Technical Service Bulletin

MODEL(S) AFFECTED: Tennant M20 (S/N 000000-003057) / T20 (S/N 000000-002097) / M30 (S/N 000000-001221). Machines manufactured prior to June 3, 2009

SUBJECT: Shaft seals on the front brush motor failing, allowing hydraulic fluid to leak.

PURPOSE: Install case drain kit upgrade to extend the life of the front brush motor seals.

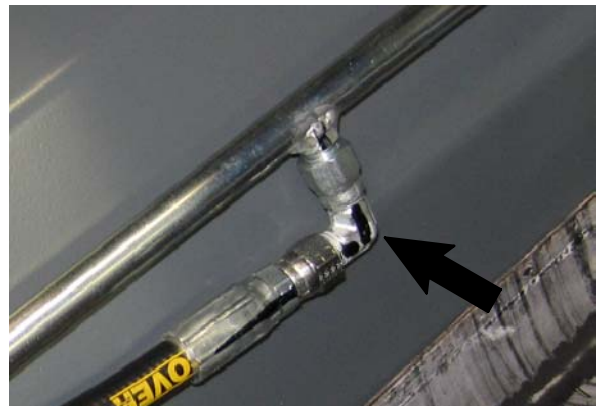
Install additional fitting on to front brush motor

Install fitting on to brush return tube

Install return tubing and drain hose on to scrub head and front brush motor

NOTES: Order kit 9006386 for M20 / T20 machines and kit 9006384 for M30 machines. The instruction bulletin for these kits is 9006383.
